**Witness: NO WITNESS
Request from: Connecticut Siting Council**

**The Connecticut Light and Power Company
Docket No. D&M Plans**

**Data Request CSC-02
Dated: 01/27/2006
Q- D&M-002
Page 1 of 2**

DETAIL 4
SH 1 | SH 5
DETENTION BASIN OUTLET STRUCTURE
NOT TO SCALE

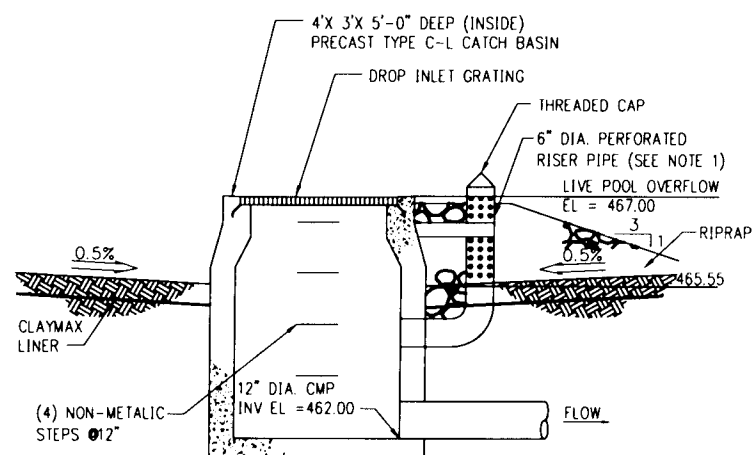
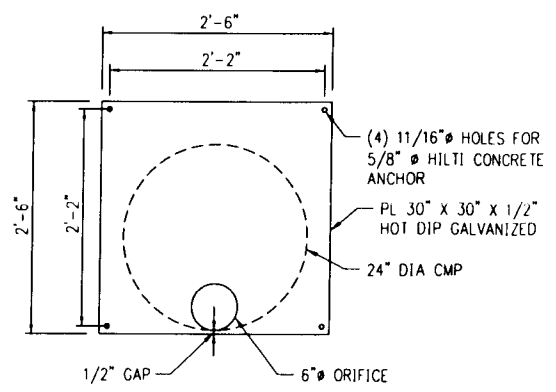
Provide profile and plan details for the following: a. three-foot retaining walls
b. detention basins including Drawing No. 11004 details 4 and 5.

A preliminary drawing (#24807-11001) showing the detail of the detention basin outlet structure (detail 4) and the galvanized orifice plate that is part of that structure (detail 5) is attached.
